***MODIFICATION REQUEST:
Wollongong Private Hospital
360-364 Crown Street and 9-11 Urunga
Parade, Wollongong (MP70_0070 MOD 1)***

- Modification to the built form, internal layout, service vehicle access and basement car parking of Wollongong Private Hospital

Director-General's
Environmental Assessment Report
Section 75W of the
Environmental Planning and Assessment Act
1979

November 2013

Figure 8: Approved WPH Built Form – Crown Street Perspective

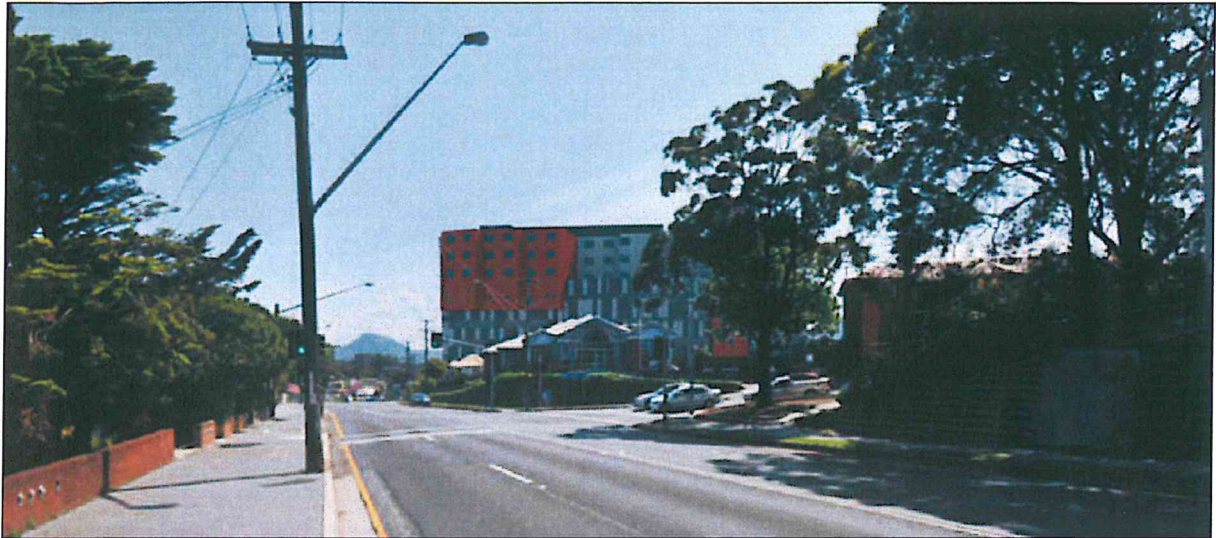
The proposed amendment to the palette of materials and colours removes the dominant staggered architectural treatment along Crown Street and the site's corner, and small framed windows have been removed. In its place, the proposed amended building design provides a more simplified and sympathetic modern building façade, clad in grey coloured panelling and larger windows to emphasise the horizontal scale of the building to minimise its dominance within the locality (see **Figures 6 to 9**).

Figure 10: Crown Street Elevation Comparison – Approved Outlined In Red

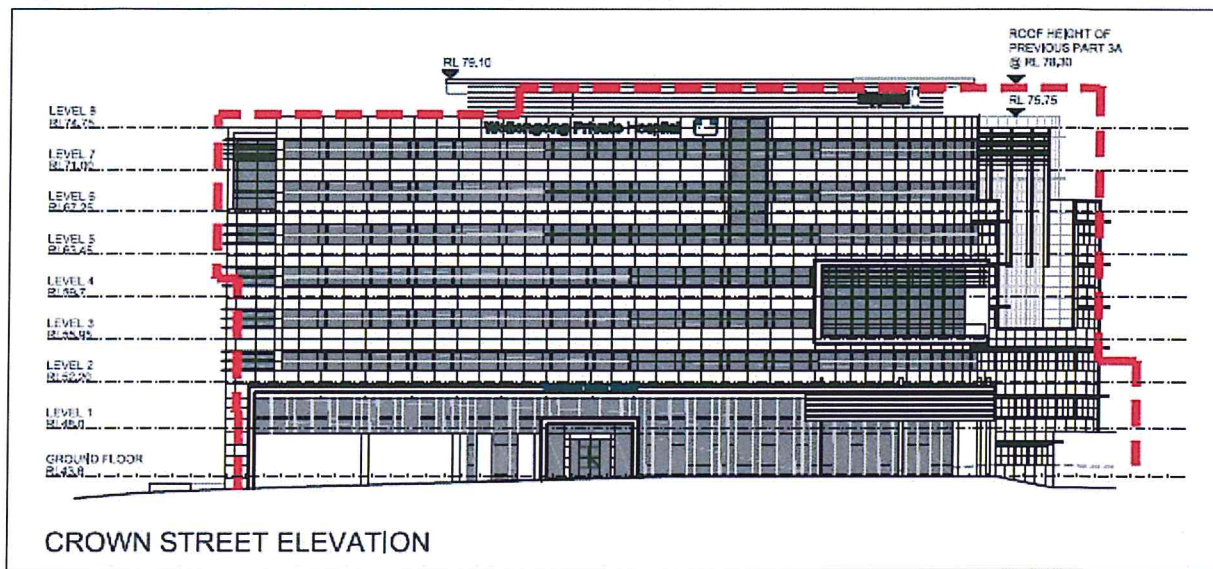
The scale of the amended building is generally consistent with the current approved design, although it is noted that a minor building height increase of 1.77 m above the 32 m LEP maximum height limit is proposed to accommodate the required floor to ceiling heights for hospital buildings. It is also noted that the top level has a reduced footprint which would also be recessed from the floors below, particularly from Crown Street. Notwithstanding, **Figures 10 and 11** demonstrate that the additional height is negligible in comparison to the original approved building (shown outlined in red).

Figure 15: Proposed Landscape Plan

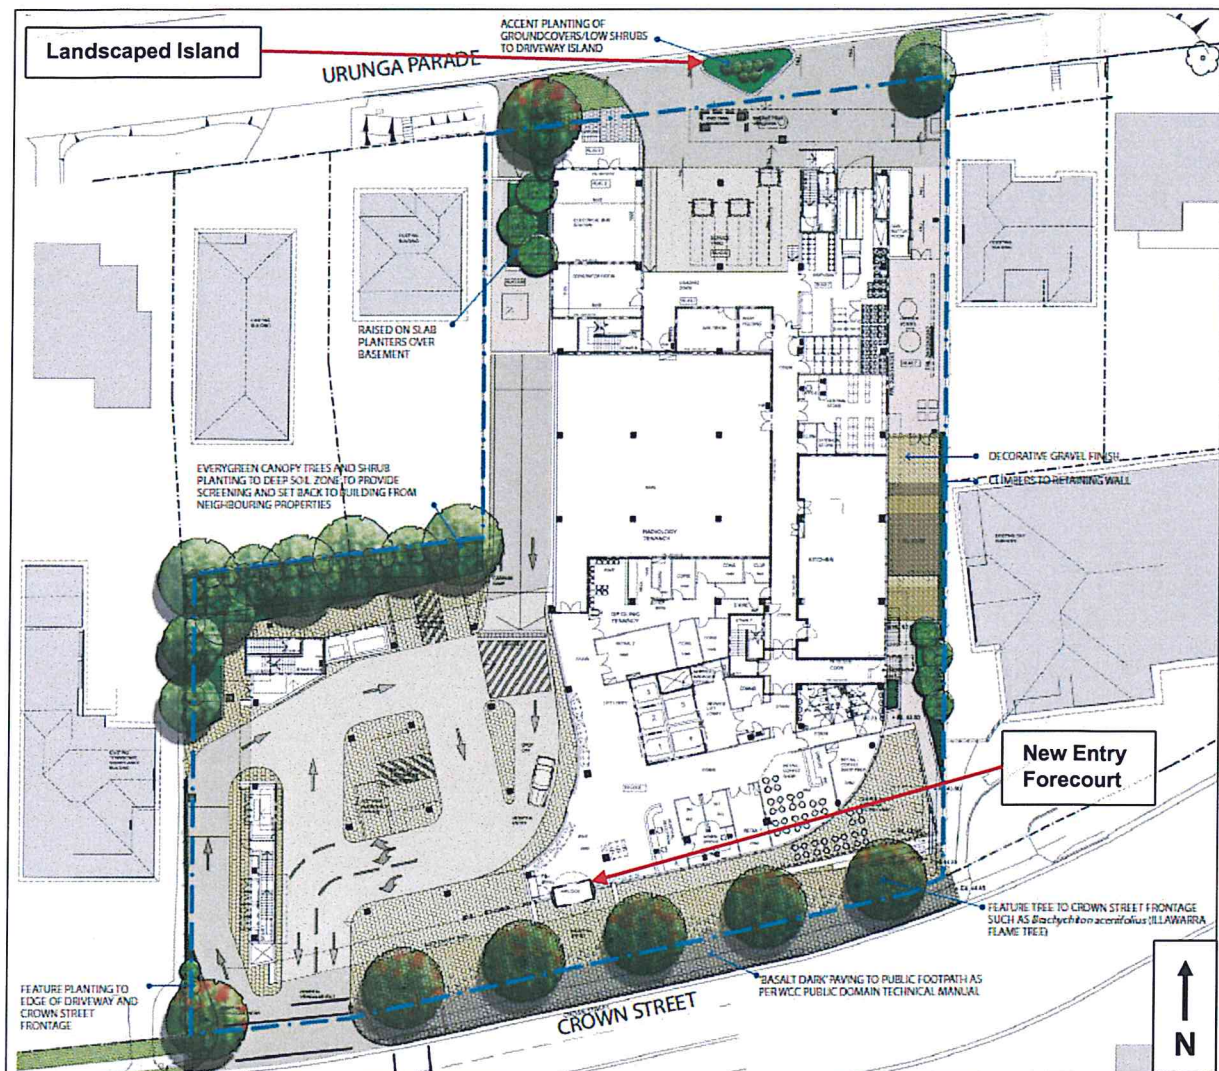
In this regard, while the proposed amended building design retains the internal vehicle drop-off area, pedestrian accessibility has been significantly improved through the introduction of the new building entry forecourt (see **Figure 15**), providing pedestrian access directly from Crown Street. In addition, the revised scheme would improve the current public domain condition of the site's Crown Street frontage, with paving, street trees and shrubs proposed (in accordance with council's technical public domain manual), a café and ground level ancillary retail (e.g. pharmacy). These works would have a positive impact on the amenity of the locality and assist in softening the building's interface as well as creating an active public domain.

Amendments are also proposed to the landscaping at the rear Urunga Parade frontage and at the side boundaries, with climbers proposed on retaining wall structures at side boundaries and increased landscape planting proposed adjacent to the rear boundary of the adjoining residential properties to the west. The proposed amended landscaping on side boundaries and the Urunga Parade frontage would aid in softening the visual impact of the hospital.

In response to concerns raised by council, a landscaped island is proposed within the centre of the Urunga Parade driveway, reducing its width and improving the outlook of the Urunga Parade elevation. Further, should pedestrian footpath facilities be installed along the southern side of Urunga Parade in the future (currently located on the northern side), the landscape island would also provide an opportunity for the establishment of a pedestrian refuge island.

The department considers that the design of the public domain and landscaping would satisfactorily complement the proposed revised design of the WPH. The use of feature street

Figure 18: Major Signage Grouping - Western Elevation

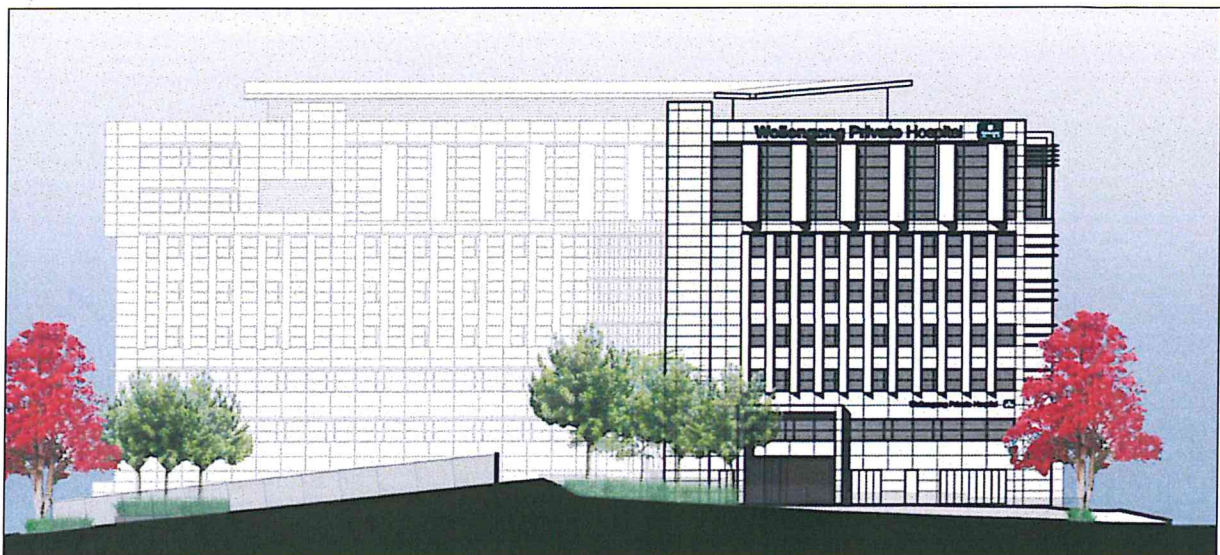
The proposed design and location of the signage is considered acceptable, noting that the location of the major signage zones do not protrude into the skyline, but sit atop of the building's elevations that would assist in communicating the building's function and location from a distance (see Figure 18). Furthermore, a 50 percent reduction in the scale of the signage as suggested by council would reduce the effectiveness of the proposed signage within the context of the scale of the proposed development. The department considers such a reduction in scale is unnecessary.

Figure 19: Typical Minor Signage (Crown Street Entrance)

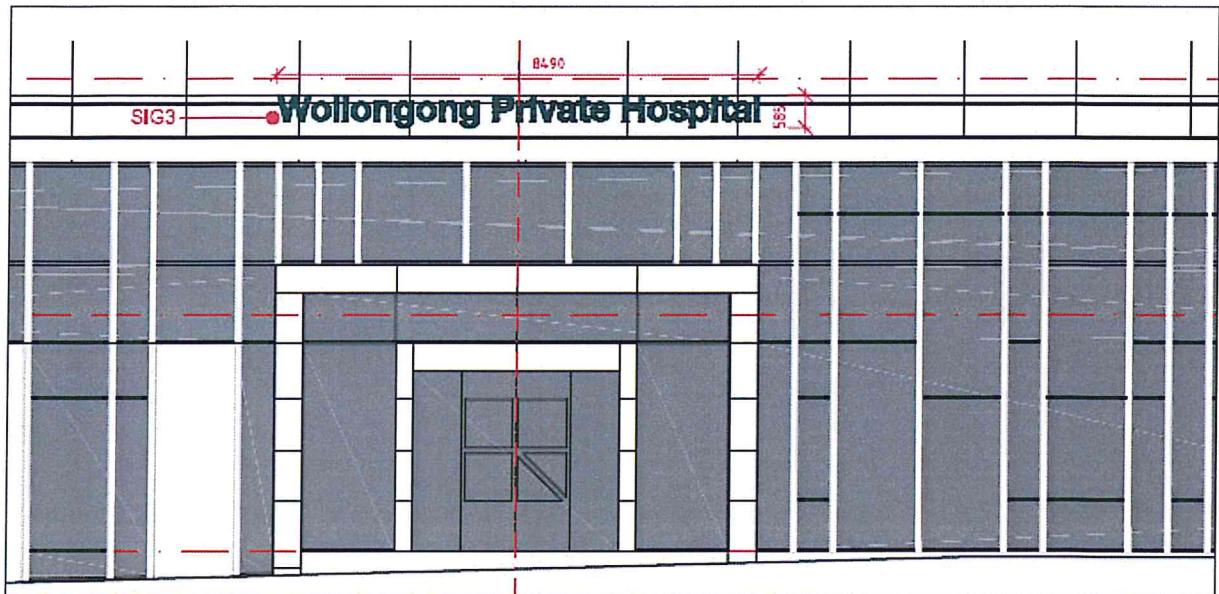
In close proximity, the visual prominence of the larger signage zones is reduced due to their location on the building's upper façade, while the smaller scale of the minor signage groupings provides a more effective message to pedestrians and visitors at street level (see Figure 19). With respect to council's comments in regarding the bold text used to highlight

the words 'Wollongong Private' as opposed to the word 'Hospital', the department notes that this would assist in the development differentiating itself from the public hospital which is within close proximity.

The department considers the proposed business identification signage to be acceptable in terms of its scale, design and its purpose and would not have a detrimental impact on the amenity or visual character of the locality. The department also notes that no concerns were raised by the RMS in relation to any potential impact on road safety.
